ECR/Documents for Information and Approval

Giulia Romagnoli and Natalya Kahn for BE-EA, 2024-01-16

ECR for Approval

Infrastructure changes in EHN2 for the future AMBER Proton Radius Measurement

Figure 2: NA FSPS System Overview

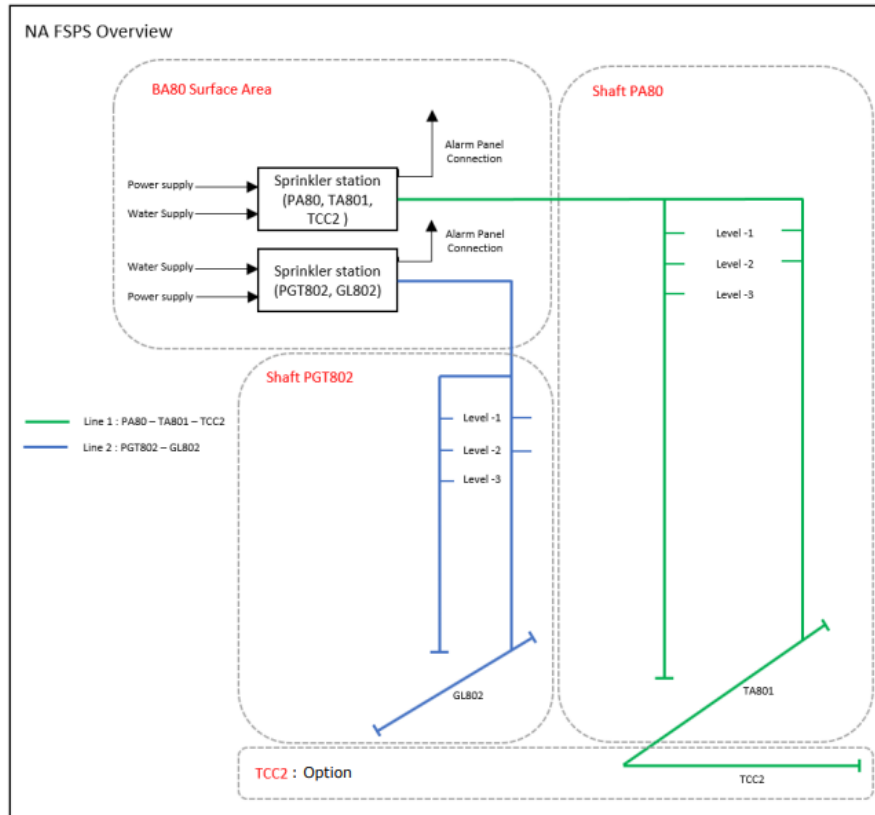
might be good to mention the reason why the radiologically challenging areas of the TCC2 and TDC2 was not considered for sprinkler installation

Figure 4: Integration model with the proposed changes.

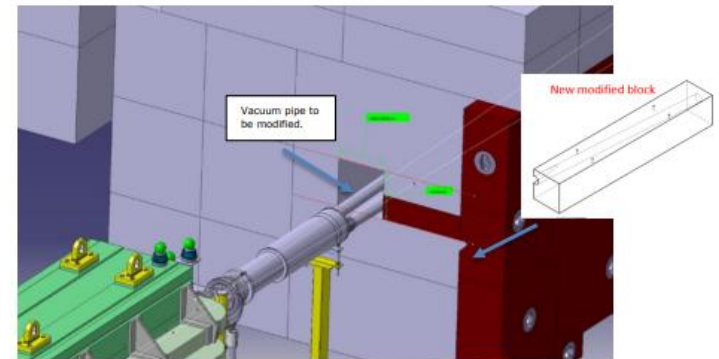
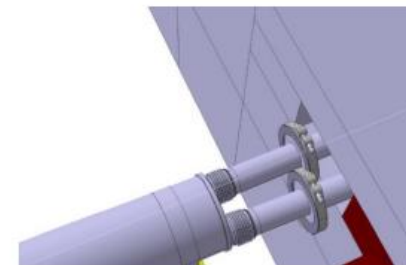
➤ Seen by GENILLON Xavier (SY-EPC) Seen	Created on 2023-12-05, 15:10
➤ Seen by VENDEUVRE Camille (BE-GM)	Created on 2023-12-05, 15:32
➤ Seen by BOZZATO Davide (HSE-RP) Seen	Created on 2023-12-05, 16:42
➤ Seen by WEISS Kurt (BE-CEM) No blocking issues but: 1. confusing figures 1 and 2: figure 1 shows the shielding blocs around the F6D.TDE018 dump, and in figure 2 one sees a shielding wall along the beamline leading to the dump (which is absent in figure 1 as well as the 2 beamlines that continue into East Hall). 2. Page 9 point 7.1 : Will the vacuum tube modification not create radioactive waste?	Created on 2023-12-05, 16:58
✔ Accepted by BOISSEAUX-BOURGEOIS Philippe (BE-EA) Ok for the vacuum aspects.	Created on 2023-12-06, 11:57
✔ Accepted by JOHNSON Elliott Philippe (SY-ABT) Ok	Created on 2023-12-06, 12:04
➤ Seen by COLLOCA Cristiana (EN-HE)	Created on 2023-12-06, 17:26
✔ Accepted by EBN RAHMOUN Aboubakr (BE-EA) OK for me.	Created on 2023-12-07, 10:50

Figure 1 — Integration Layout of the TNC experimental area.

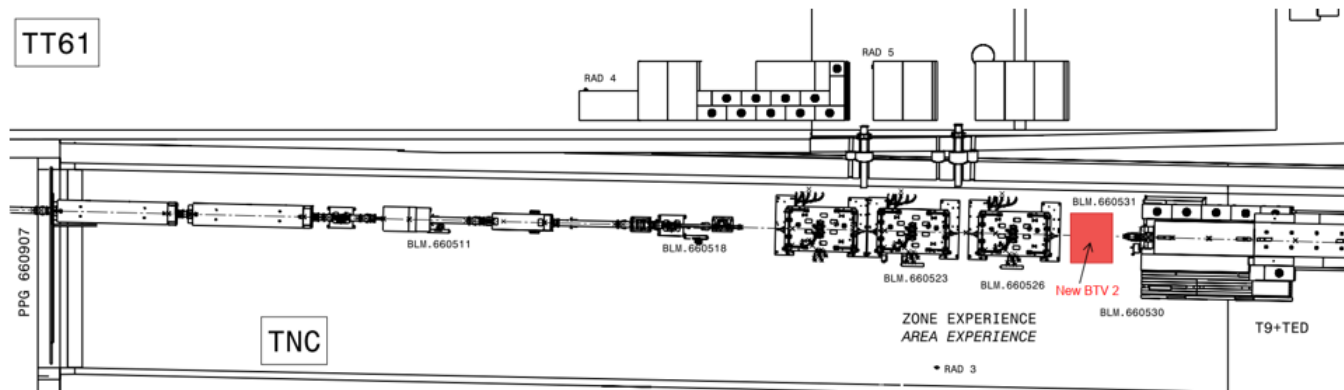
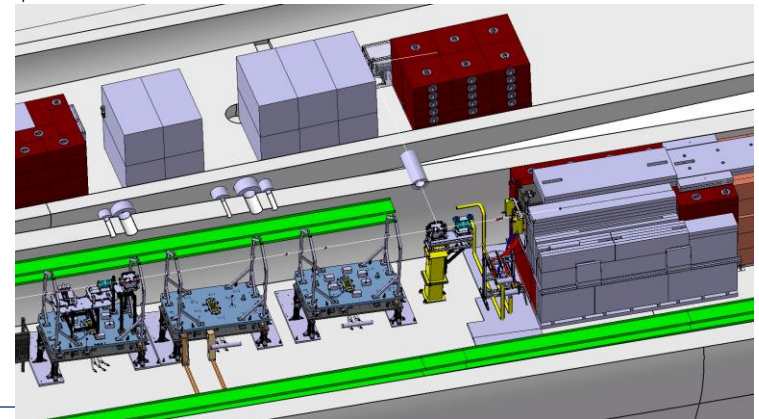
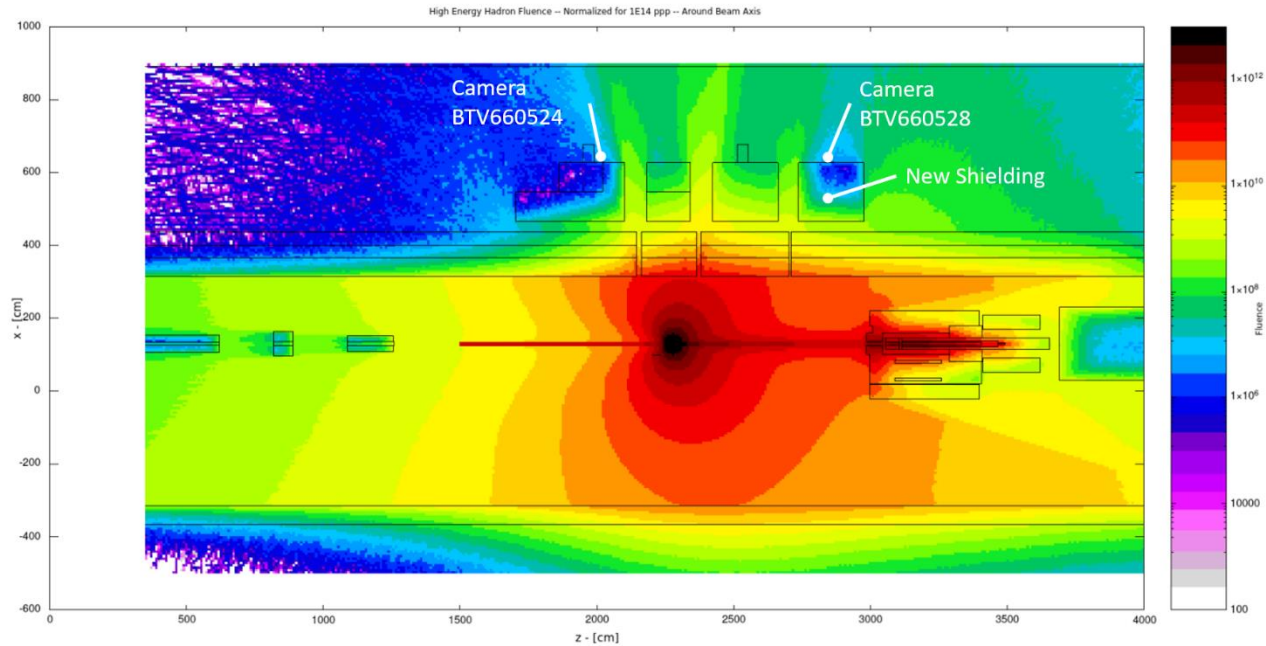
[ref study FLUKA] is a bit unclear, is it a reference to Figure 3 or a separate document ?

To answer Federico's comment, a presentation of the FLUKA study is available here:
<https://edms.cern.ch/ui/#!/master/navigator/document?D:101367090:101367090:subDocs>
Could be added in the reference section.
Stephane

Figure 5: **NEW** expert name convention proposed by this ECR.

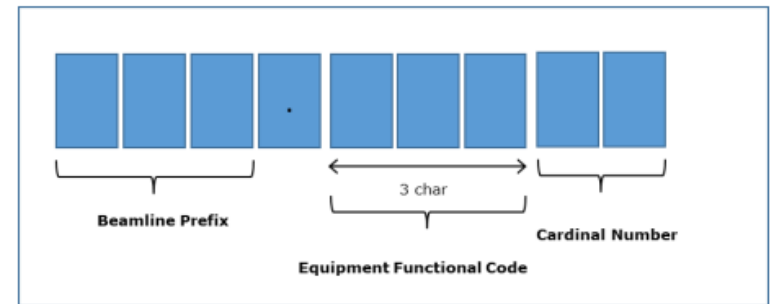
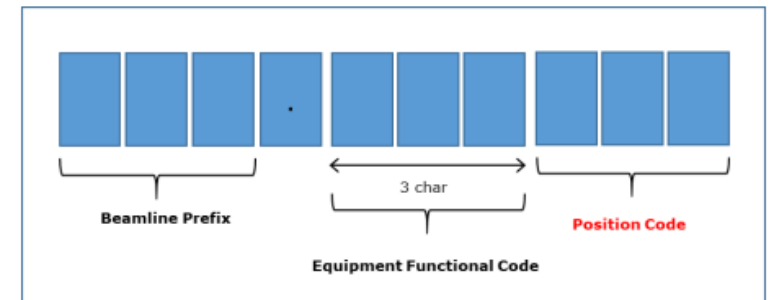
Small mistake in the Excel file for the OLD OP name (column H): T11.QDE02 should read T11.QDN02.

An incompatibility has been pointed out by M. Peryt for CESAR, as CESAR uses virtual devices to control the FGC power converters, and these virtual devices cannot have the same name as the new FGC OP devices (column I of the Excel file).

Together with EA a solution has been identified and will be implemented:

- The virtual CESAR power converter devices will get a 'Z' in front of the transfer line name, e.g. ZT08.BHZ005 or ZT09.QDN034.

- In the CESAR GUI there is an INFO column, which will mention the NEW circuit name (column D of the Excel file), to guarantee that there is no confusion when calling an EPC expert.

Small mistake in excel file [EDMS 2271129](#) already corrected the FILE PSZ-M-EN-001-1.5_modif is the correct one!
